**TO:** Development Review Board  
**FROM:** Scott Gustin   
**DATE:** May 20, 2014  
**RE:** 14-0038CA; 395 Manhattan Drive

**Request:** Demolish existing residential structure and construct new duplex

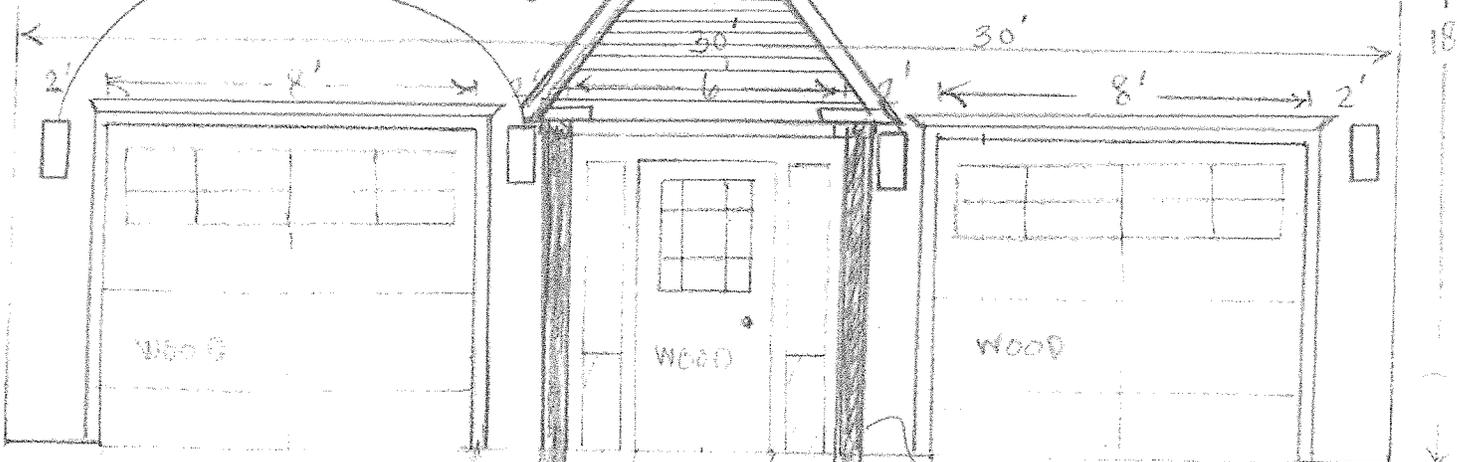
The front façade includes two garage entries. As originally recommended by the DAB, the front entry has been extended outward to project beyond the plane of the garage doors. Note that this projection is not reflected on the side building elevations or on the site plan. As a result, the extent of projection is unclear. This item needs to be corrected on revised plans. The garage doors comprise some 53% of the total front façade width. This width is permissible so long as they are under a single roofline and wholly integrated into the overall building design and there is living space above them. Such is the case here. **(Affirmative finding if conditioned)**

Fenestration details provided are limited. The window specification sheet depicts 1-over-1 double hung units whereas the elevation drawings suggest large 2-over-2 casement or awning units on the front and rear elevations. Perhaps they are side-by-side double hung units with mullions between. Clarification is needed. Side elevation windows are clearly 1-over-1 double hung units. Trim and casing details are also lacking or noted as “optional.” Discussion of the windows with the DAB covered a myriad of options but no final decision. Building entries are fairly clear with specification sheets provided for the front door and the sliding rear doors. **(No finding possible)**

Exterior building materials consist of wooden or fiber cement clapboards and fiberglass windows. Asphalt shingle roofing is proposed. Trim materials are not noted and must be. No corner boards are depicted on the elevation plans. Presumably, they will be installed. No water table is evident at the bottom of the clapboard siding. Whether one will be installed or not is unclear. Details are needed. **(No finding possible)**

The new building will be subject to current egress requirements. The basement is proposed to be finished, and egress will be provided by way of egress windows. No egress windows for the basement are evident in the building elevations and must be depicted. Building entries will be illuminated. **(Affirmative finding if conditioned)**
